Response to Referee #2 and Referee #3:

The work of Qiao et al., focuses on the PWV and AOD retrievals of EKO MS711 and MS712. The method presented is based on methods of other instruments, but it is novel and since the spectral measuring instruments are becoming more popular, will become valuable in the future and fits the scope of AMT. However, the manuscript is poorly written, a lot crucial information for the reproducibility of the methodology are missing and the validation of the retrievals is very shallow. Hence, I suggest to be considered for publication after major changes.

Figure 1 FWHM (a) and wavelength accuracy (b) of MS711 and MS712 (<https://www.eko-instruments.com/us/categories/products/spectroradiometers/ms-711-spectroradiometer>)

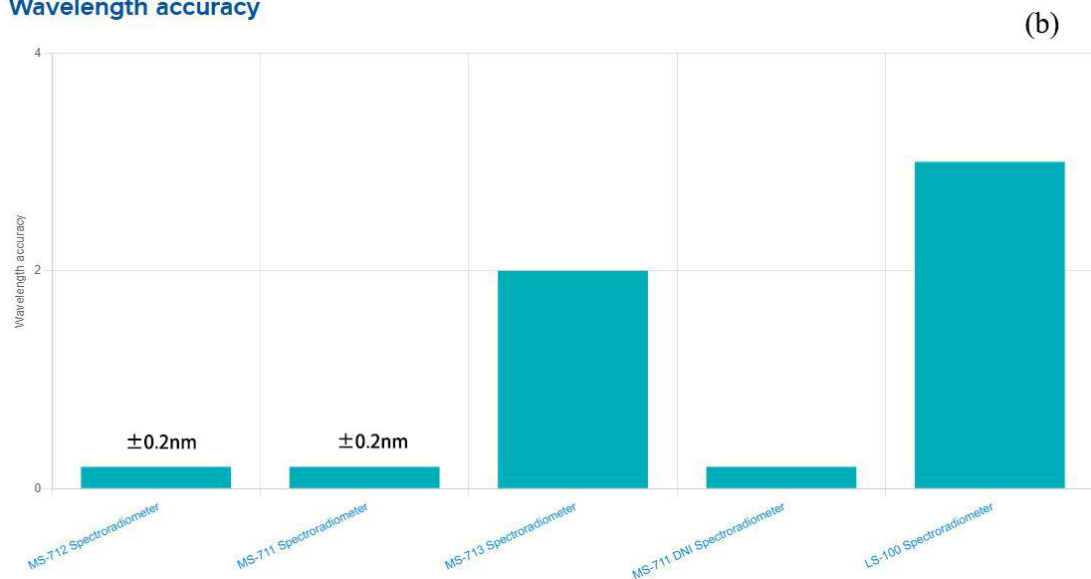
1. The two instruments are considered as one for most of the manuscript. I think it should be separated and make clear what is the performance of each one. Since the area around 940nm is overlapped by both them, the comparison of the measurements should be presented. Also, the different spectral steps and FWHM will result to very statistics in the validation process. It is crucial to present that, since the instruments are usually sold and installed separately and also in case of parallel operation, a decision should be made for the overlapping region. Finally, in section 2 more details should be mentioned such as the calibration of the instruments, the reported uncertainty and their measuring schedules. Specially, the calibration of the spectral bands is very important and could lead to high deviations for the algorithm. Is there any wavelength shift? How are the spectral channels characterized?

Response: Thank you for your comment. We reconfirmed that the radiometric measurements used in the 900-990 nm band are from MS711 recorded data. We found

the relevant descriptions of the FWHM and wavelength accuracy of MS711 and MS712 from EKO Instruments official website. As can be seen from Figure 1(a) and (b), the full width at half maximum of both is $<7\text{nm}$, and the wavelength accuracy of both is $\pm 0.2\text{nm}$, so the wavelength drift hardly affects the inversion results. In addition, we contacted EKO in Japan and obtained the calibration certificates of MS711 and MS712. From the certificates, we learned that both instruments were accurately calibrated in Japan in 2018. The uncertainty of calibration is shown in Table 1. we performed a specific analysis of the inversion uncertainty due to the calibration uncertainty in Sect. 4 of the submitted manuscript.

Figure 2. Scatter plot of the water vapor retrievals obtained from BAND1 and BAND2 of the test spectrum versus the input PWV of the simulated spectrum and their linear fits.

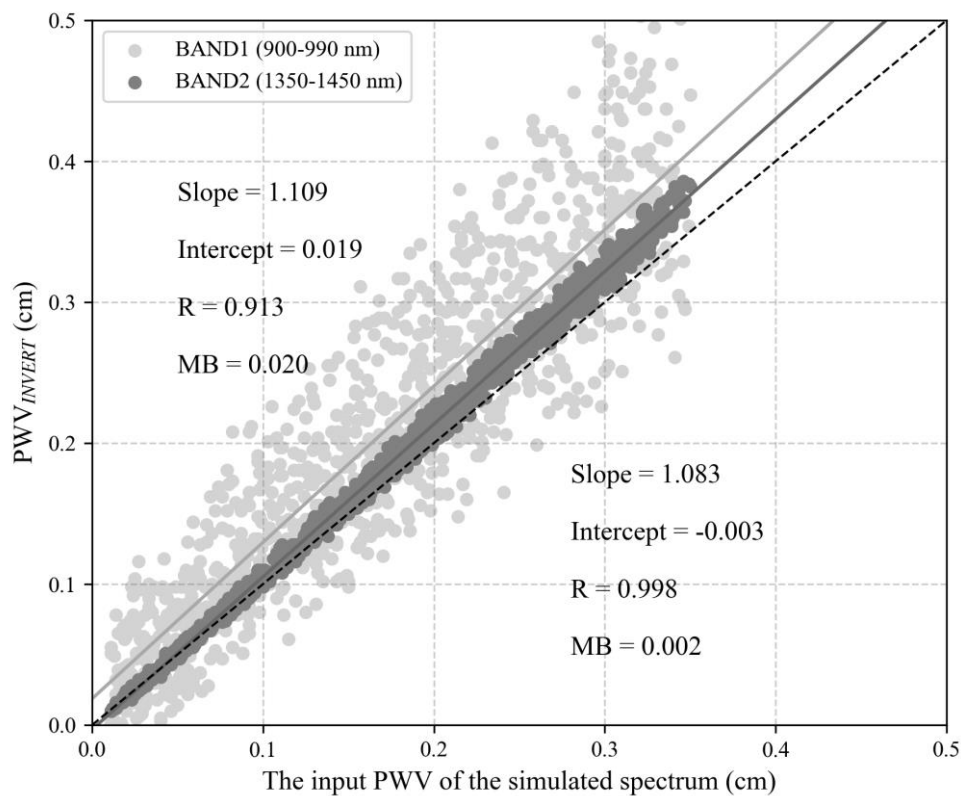
6. L117 Results showed in figure 5 are not enough to prove that one band is more efficient than the other. We don't know what is the testing sample, how representative is and all other effects on the measurements are already eliminated. A discussion leading to figure 5 is clearly missing.

Response: Thank you for your comment. I am very sorry that our explanation of this part is not clear enough in the previous manuscript. In order to test the PWV retrieval efficiency of BAND1 and BAND2, the spectral curves used in our test are based on MODTRAN simulations with random noise added afterwards. In spectral simulations,

the US standard atmospheric model was used with random PWV between 0-0.5 cm, and solar zenith angle between 0°-30°, regardless of cloud and aerosol. Then the simulated spectral was superimposed a random noise of $\pm 5\%$ on each wavelength to generate the test spectral curves. Figure 2 shows the results of the inversion test using the two bands, the PWV retrievals of the band near 1370nm are closer to the input PWV when the spectrum is simulated, and it is more stable, which demonstrates that the band around 1370 nm may be more suitable for water vapor retrieval in dry atmosphere than the band around 940 nm for the water vapor inversion using the method in Sect. 3.2.

The result plot of the inversion test is different from Figure 5 in the previous manuscript because noise was previously added to the overall spectrum of the MODTRAN output. When checking the manuscript, considering that this was not reasonable, we redid the inversion test and added noise on each wavelength of the mode output spectrum.

Figure 3. The transmittance without Rayleigh scattering and continuous water vapor absorption in the EKO band simulated by MODTRAN, where the transmittance value greater than 0.999 is marked in black, and the rest are marked in grey.

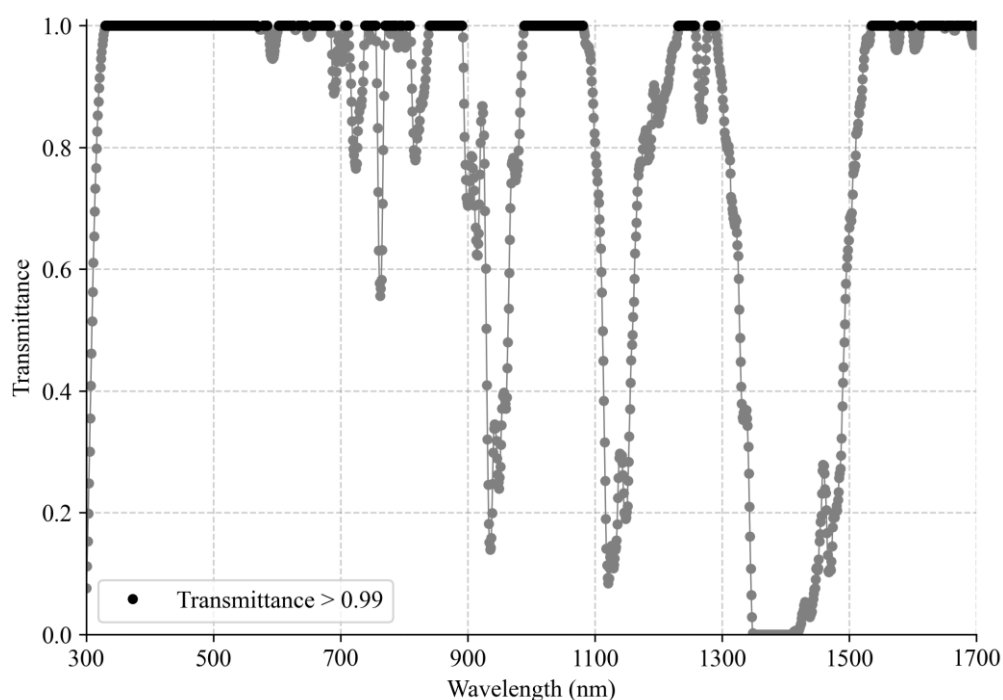
7. 3.2 It is not clear at which wavelengths this inversion will be used. It is a odd to name this aod inversion in general, since it is not valid for the most wavelengths (where other

gases absorb). I suggest to focus in water vapor bands and close bandwidths and just calculate aod for those and keep the full aod inversion for future work that will include more trace gases.

Response: Thank you for your comment. We have added Figure 3 to Section 3.3 of the manuscript, marking the wavelengths used for AOD inversion, specifically those with transmittance greater than 0.999 excluding Rayleigh scattering and continuous absorption by water vapor. The AOD for other wavelengths are obtained by high-order fitting. In addition, thanks for your suggestion, we have stated in the article that the EKO instruments have the potential to provide spectral AOD, and we are also considering your suggestion to use the spectral AOD of this instrument for other trace gases retrieval.

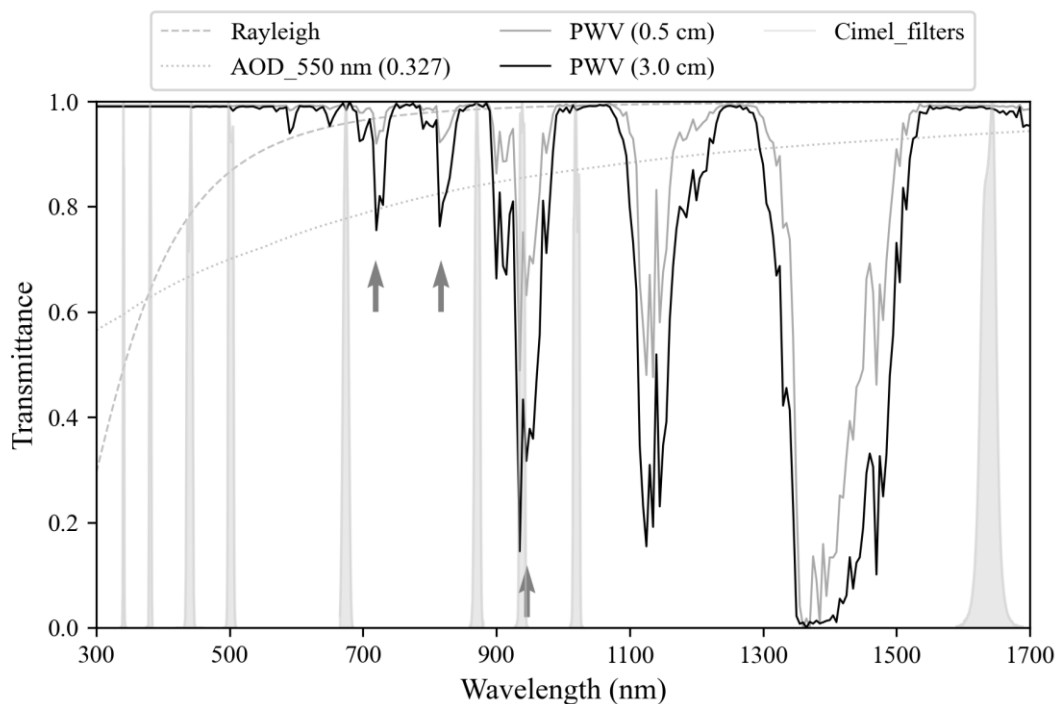
12. Figure 3. I don't understand the purpose of visualizing cimel filters. Also, the aerosol line, corresponds to a specific AOD (which will change the transmittance). Please change the legend to the actual AOD value. Also, move the legend to a position that does not hide the drop at 1300-1500nm.

Response: Thank you for your comment. Referring to your suggestion, we have changed the original Figure 3 to Figure 4. The spectral response curves of the CIMEL filters in the figure are drawn to show the position of the CIMEL measurement band more intuitively.

Figure 5. The AOD was retrieved by EKO and provided by AERONET-CIMEL on 06 June 2020 (15:22 UTC+8), the dashed line is the spectral AOD obtained by the AOD_{EKO} high-order fitting.

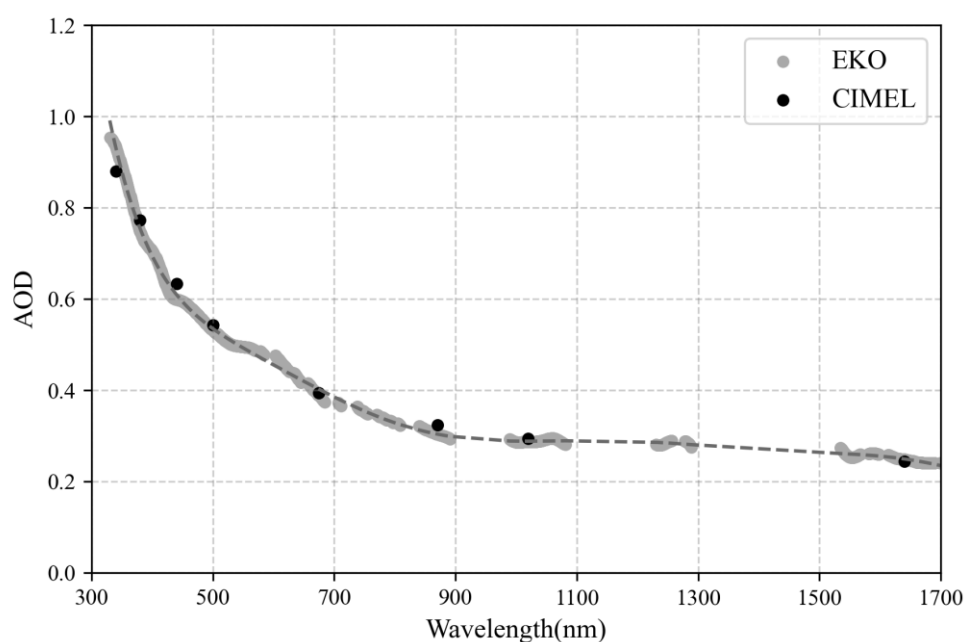
15. Figure 8. It is not wise to provide spectral AOD, when all the trace gases but the water vapor are ignored.

Response: Thank you for your comment. It is indeed unreasonable to provide the AOD of the spectrum ignoring the absorption of gases other than water vapor, so we have added some clarifications to the manuscript in conjunction with your suggestion and changed Figure 8 in the previous manuscript to the following figure. (Lines 240-247)
